PLANNING BOARD AGENDA

DATE: Tuesday, December 13, 2022
TIME: 6:00 P.M.

PB22-9: 771 & 787 Main St. (Map 6, Lots 43, 44, & 154) – Clover Farm Subdivision (8 lots) – Preliminary Plan

To: Planning Board
 From: Jeff Brubaker, AICP, Town Planner
 Cc: Ken Wood, PE, Attar Engineering, Applicant's Representative
 Mike Sudak, EI, Attar Engineering, Applicant's Representative
 Shelly Bishop, Code Enforcement Officer
 Date: December 10, 2022 (report date)
 December 13, 2022 (meeting date)
 Re: PB22-9: 771 & 787 Main St. (Map 6, Lots 43, 44, & 154) – Clover Farm Subdivision (8 lots) – Preliminary Plan

SCALE: 1" = 50'	APPROVED BY:	DRAWN BY: MJS
DATE: 08/23/22	FILE: MAIN ST REV BASE.DWG	REVISION DATE: C : 12/06/22
JOB NO: C174-21	SHEET: 8

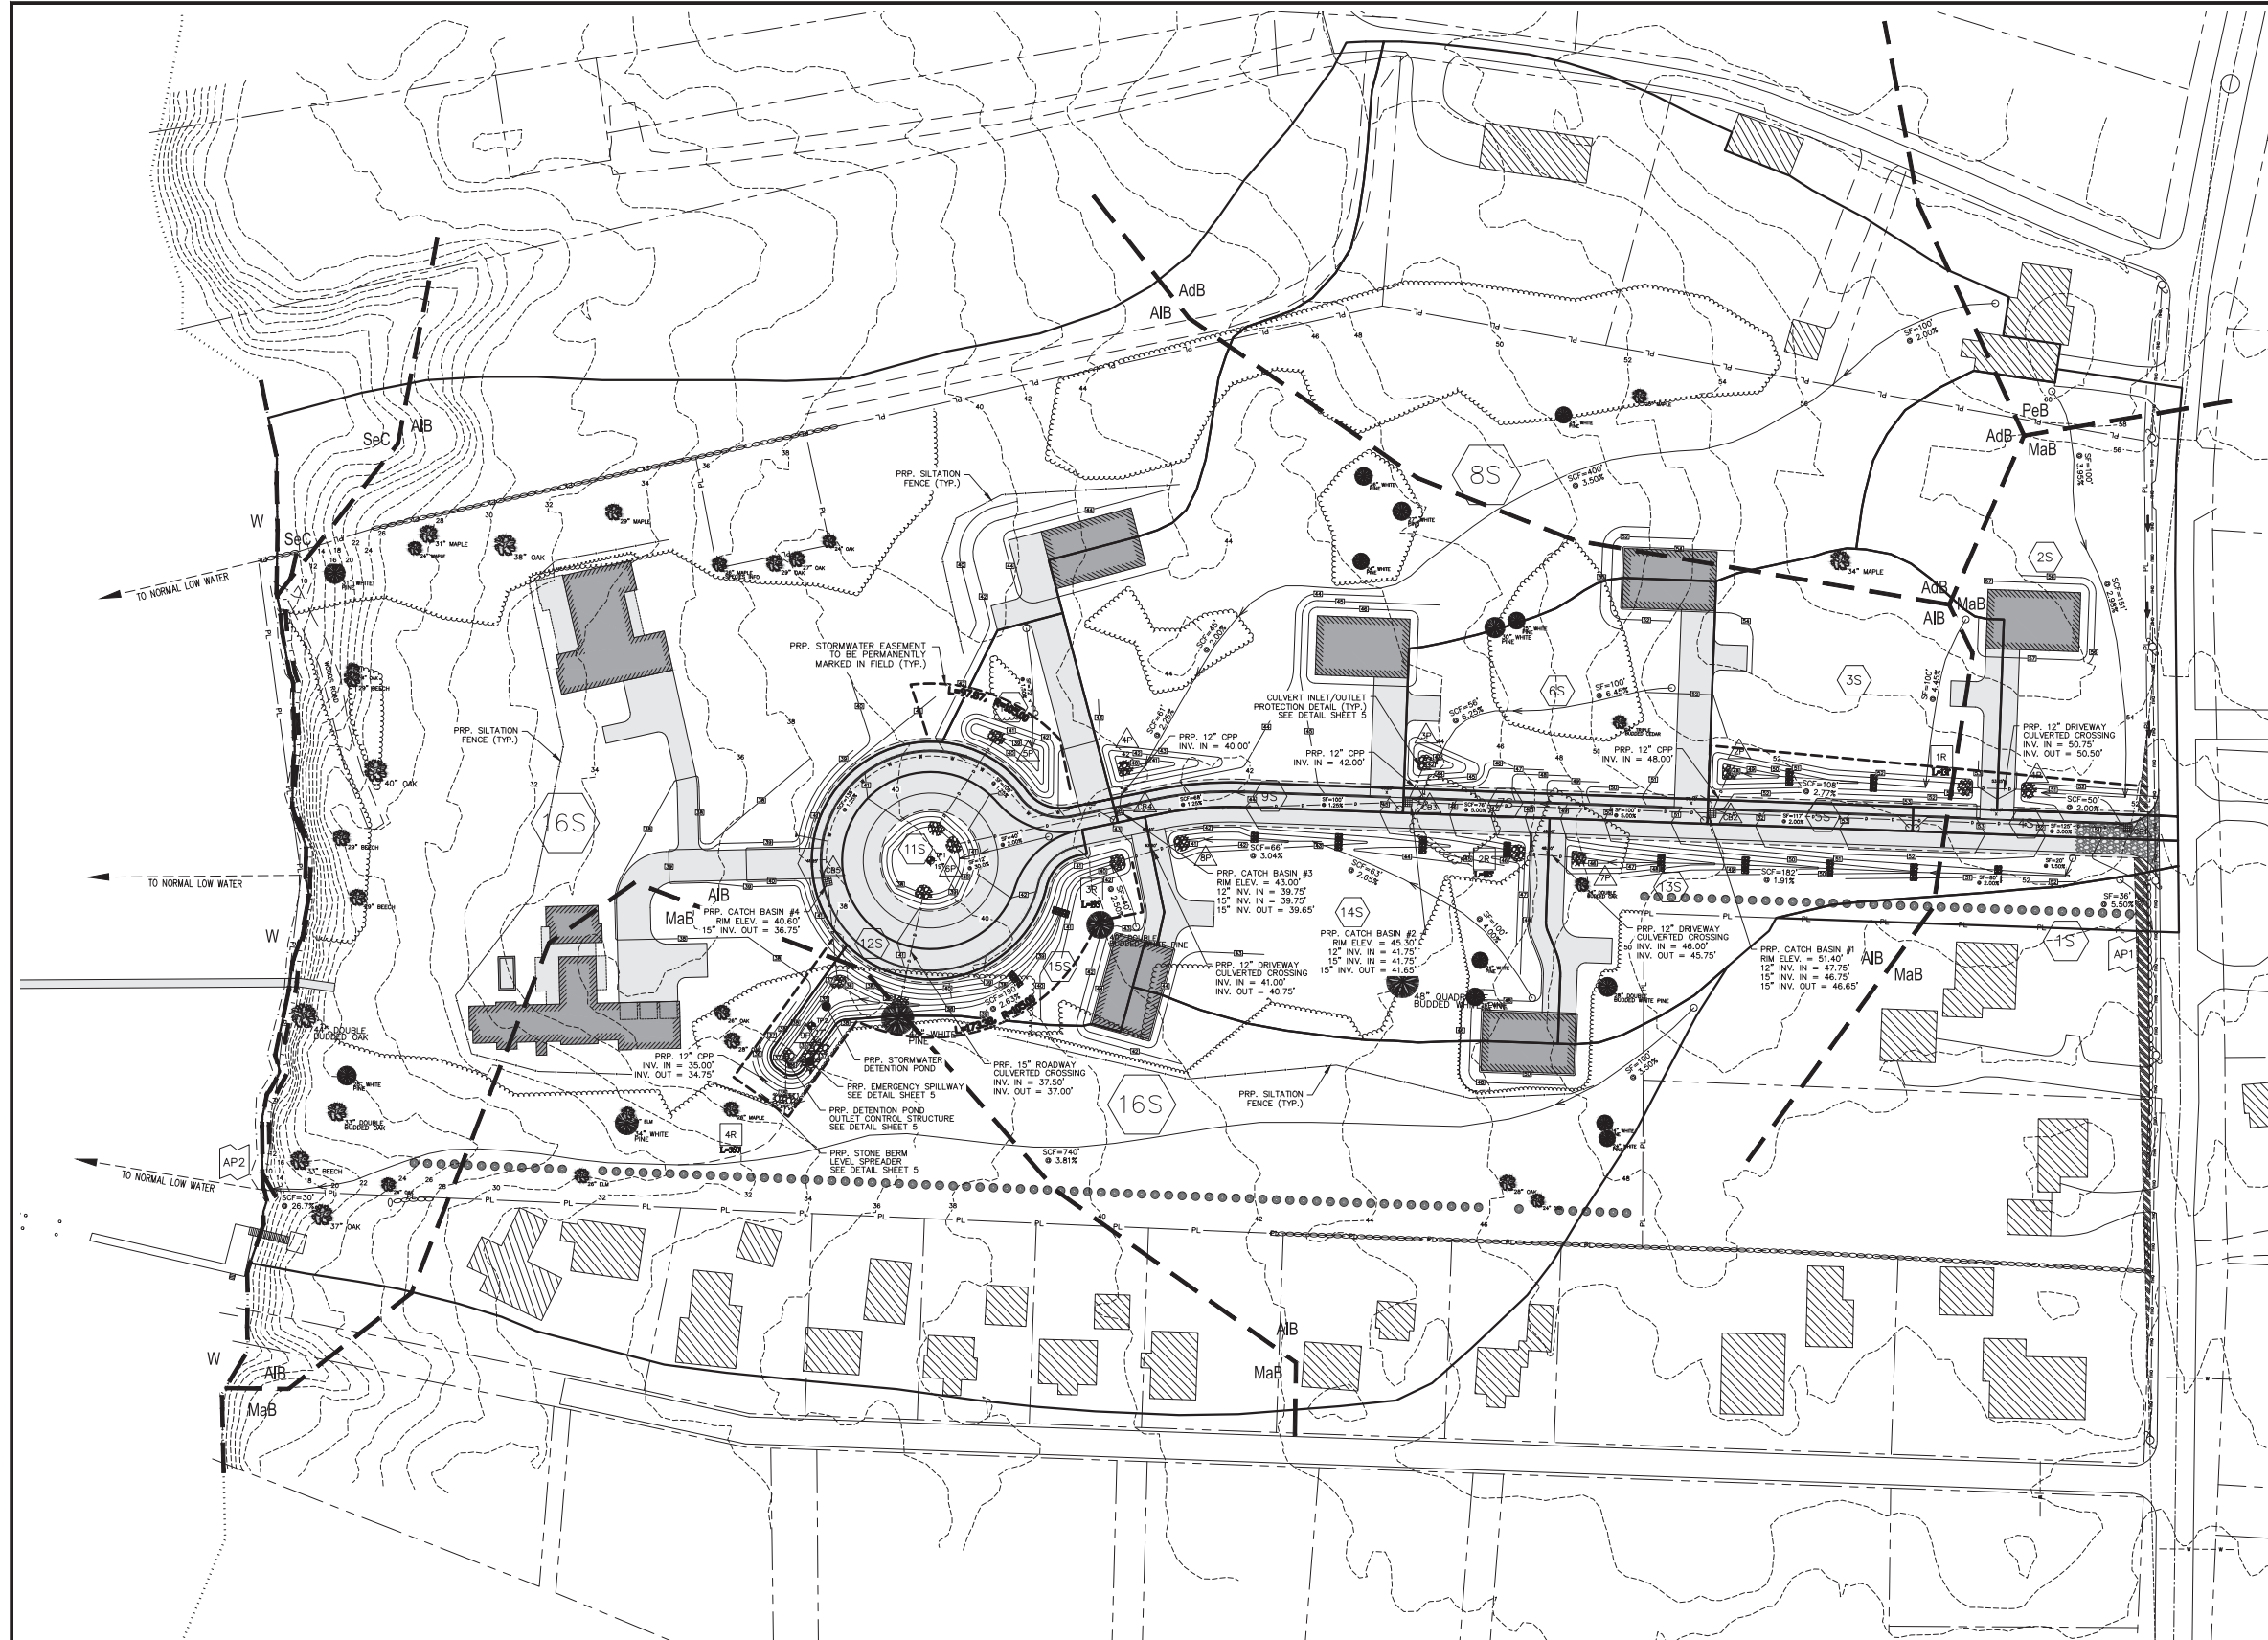
Note the two new test pit results from Michael Cuomo, in your packet. Both test pits found Nicholville soils that are soil group D, moderately well drained. Test pit locations are shown on current site plan sheets 7-8.
